Justification for Class II permissive change – AT&T1430

FCC ID: EW780-5125-H01 & EW780-5125-B01

The description Difference Between AT&T1430 and AT&T1430MK2

Fig.1 Block diagram

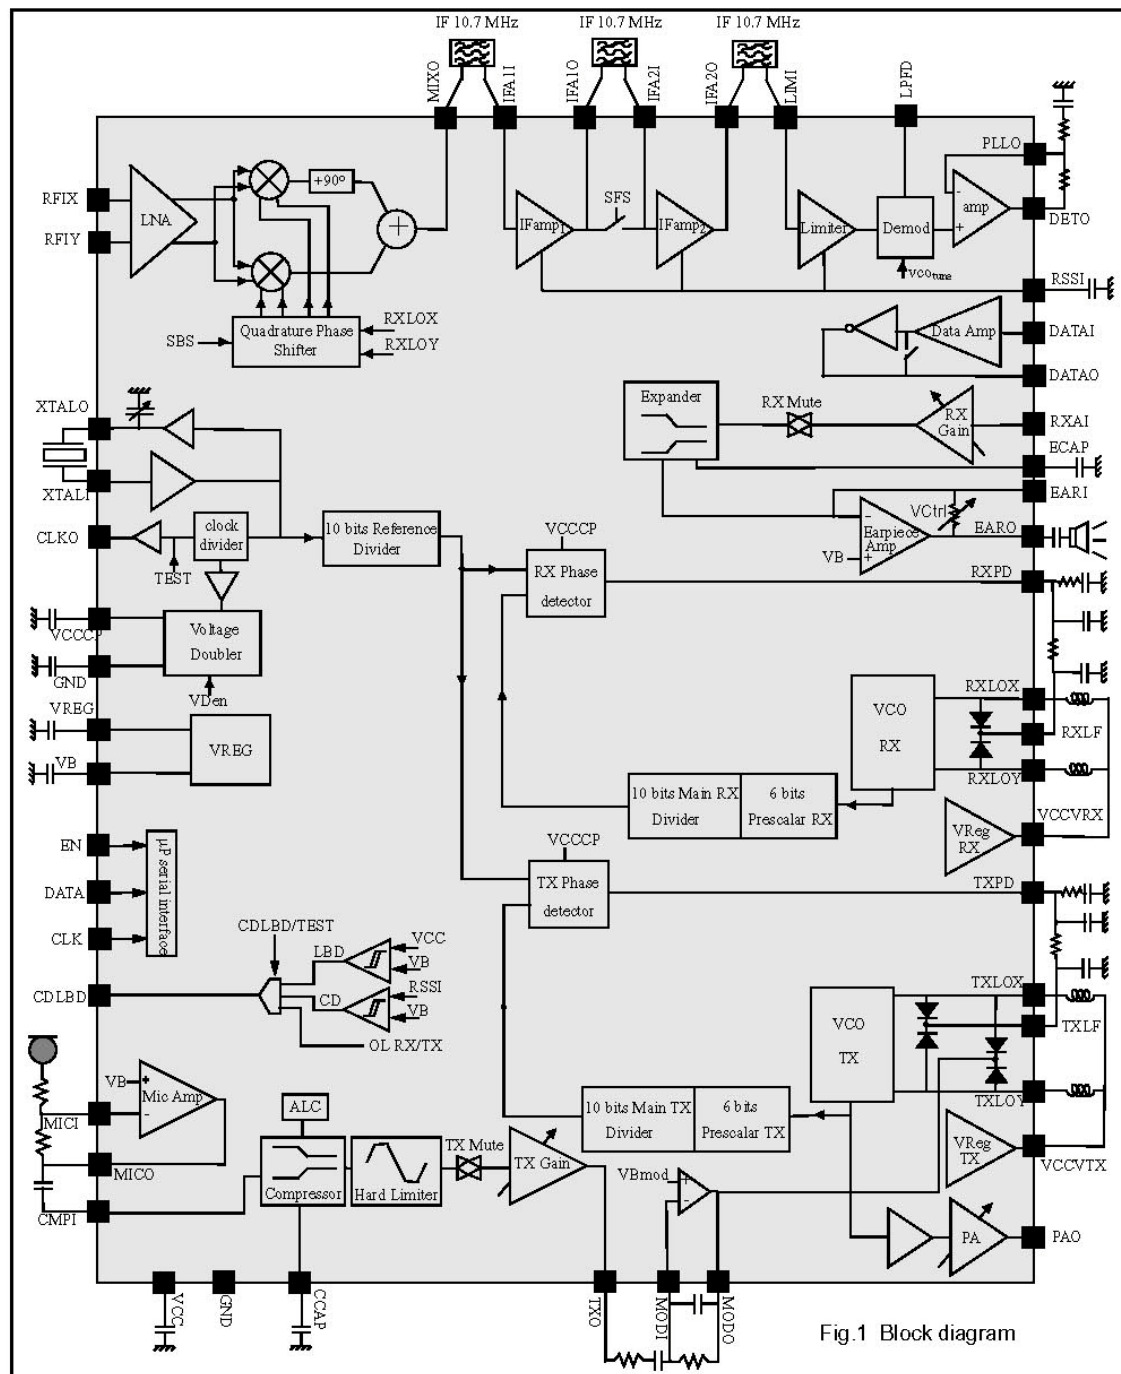
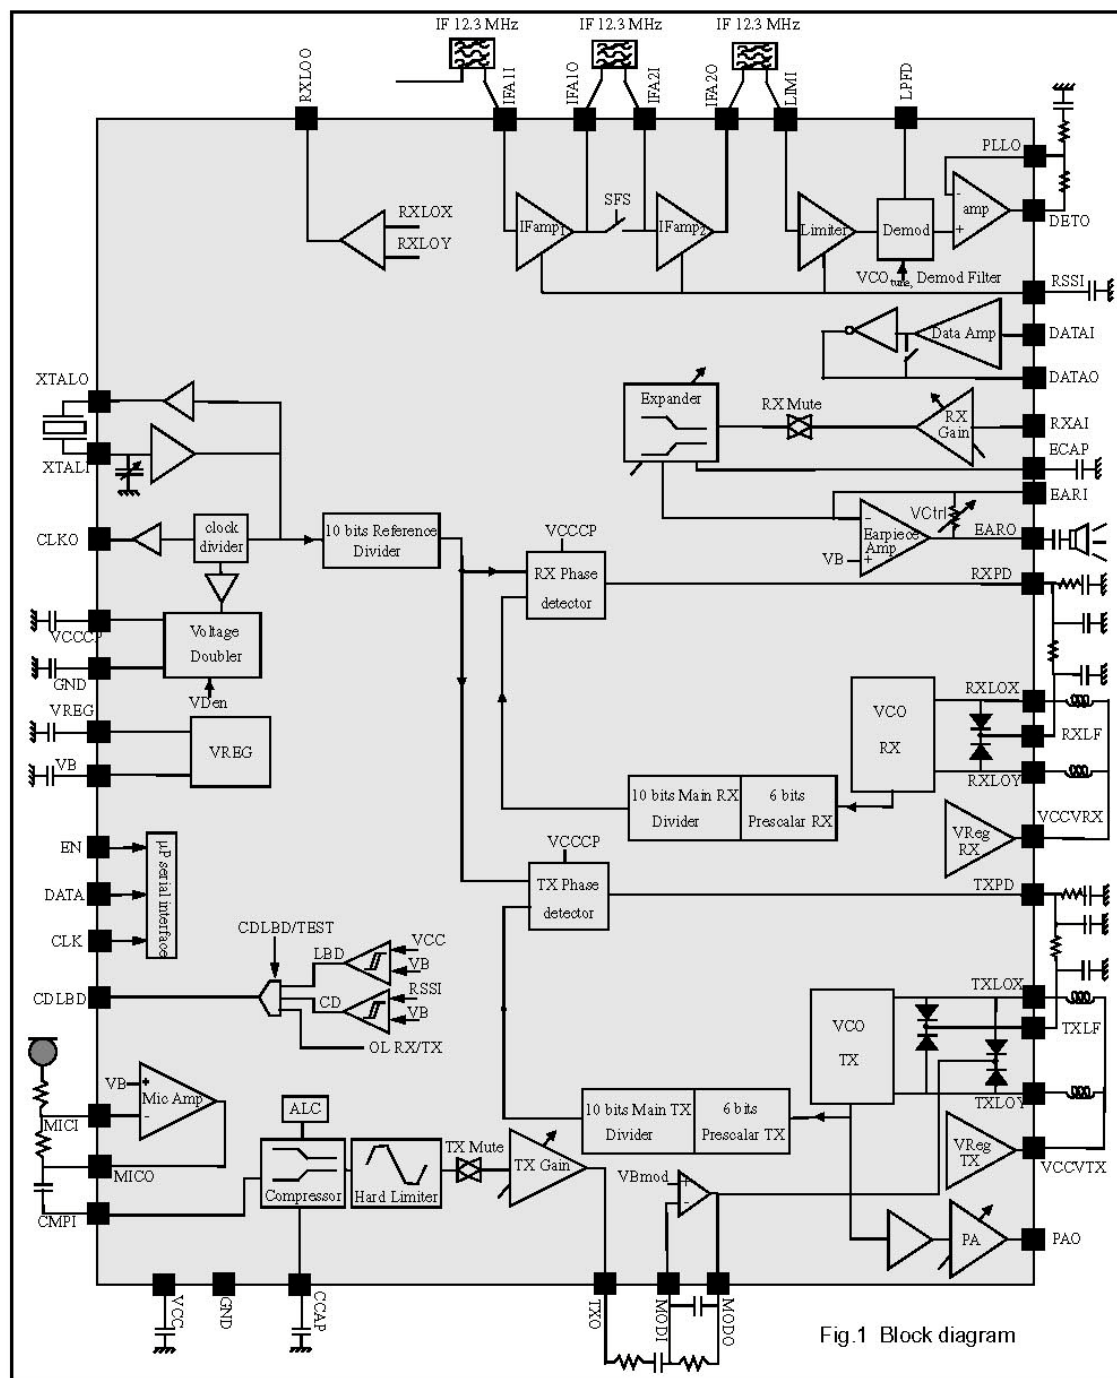
- a) Internal block diagrams of U3515 (old) & U3517B (new) – attached.
U3515 is a 900MHz RF IC, so in previous design the Rx PLL, VCO, LNA, Mixer could not be used on Handset receive (2.4GHz).
In the new U3517B, the Rx PLL, VCO are re-designed for 2.4GHz, so previous external discrete Rx PLL, VCO are no longer required. The unused LNA, Mixer inside U3515 were not implemented in the new RF IC U3517B as shown in the block diagram.
- b) The above was also mentioned in the Theory of Operation filed in FCC during previous new approval (10/1/01) on EW780-5125-H01 & EW780-5125-B01. The full doc. can be available for comparison when request.

- 1) Tx – using discrete components to replace LC filter is not considered as major change.
- 2) Rx – the integration of Rx PLL & VCO to RF IC U3517B is a planned migration that keeps all RF stages & frequencies remain the same. This will not affect the intended radiation & the unintended radiation was tested & verified to be within FCC limits.
